Department of Mechanical Engineering
THE UNIVERSITY OF TEXAS AT AUSTIN

SUBJECT: Docket No. 50-602, Request for Renewal of Facility Operating License R-129

REF: UNIVERSITY OF TEXAS AT AUSTIN - REQUEST FOR ADDITIONAL INFORMATION REGARDING THE
LICENSE RENEWAL REQUEST FOR THE NUCLEAR ENGINEERING TEACHING LABORATORY TRIGA
MARK II NUCLEAR RESEARCH REACTOR (TAC NO. ME7694)

ATT: RAI RESPONSES

Fig., Zirconium Hydride Phase Diagram¹

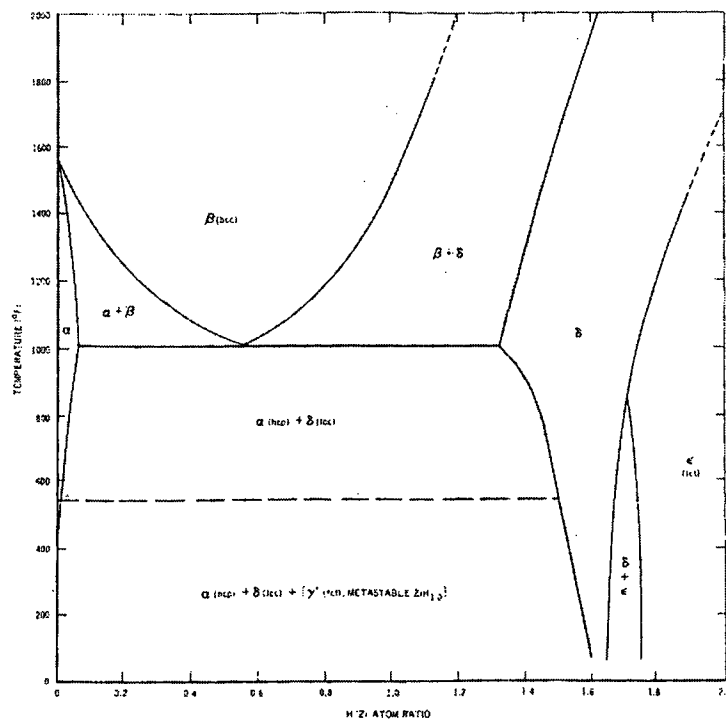
UT SAR Section 4.2.1 provides Figure 4.1 which relates TRIGA fuel phases to fuel temperature. A previously NRC-accepted diagram is from the Simnad Report (E-117-833, May, 20, 1986) which is the underlying basis for the TRIGA fuel SER (NUREG-1282). The Simnad diagram is significantly different from the one presented in the UT SAR. Please confirm that the UT SAR statements and conclusions are either based upon NUREG-1282 or provide a basis, methodology, and analysis for any differences.

NUREG-1282, *Safety Evaluation Report on High Uranium Content, Low Enriched Uranium-Zirconium Hydride Fuels for TRIGA Reactors*, has the expressed purpose of authorizing the use of higher weight per cent fuels, above the 8.5 w% fuel previously approved in a license 1978 amendment. In comparing the new w% fuel to the “standard” fuel, NUREG 1282 references a General Atomics report (Simnad, M. T., “*The U-ZrH_x Alloy: Its Properties and Use in TRIGA Fuel*,” E-117-833, GA Technologies, Inc, San Diego, CA, February 1980). Although the report is on its face the underlying basis for approval of uranium content exceeding the “standard” 8.5 w%, the Simnad diagram is extracted below and will be placed in the revised, proposed SAR.

Radiation Survey of Reactor Shield System

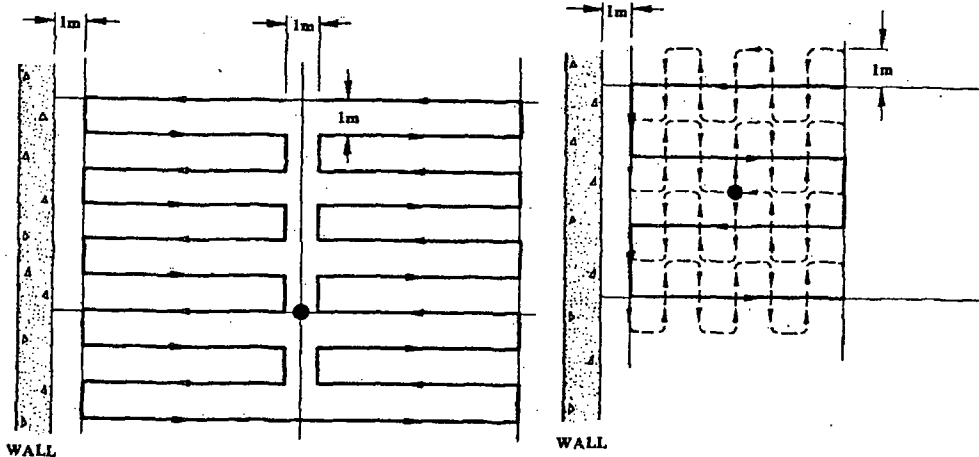
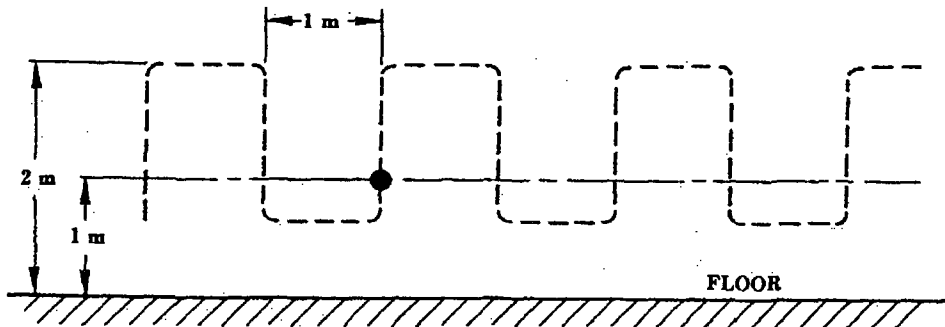
RAI 6: The guidance in NUREG-1537 Section 4.4, "Biological Shield," requests that the licensee provide a description of the biological shield and how it assures acceptable control of personnel exposure. UT SAR Section 4.4 includes a statement, "One goal of the design is a radiological exposure constraint of 1mrem/hour for accessible areas of the pool and shield system." Please describe methods used to demonstrate acceptable radiological exposure.

Attached is an excerpt from the Nuclear Engineering Teaching Laboratory Startup Program describing the methods used to perform acceptance surveys of the biological shield during initial commissioning of the facility.
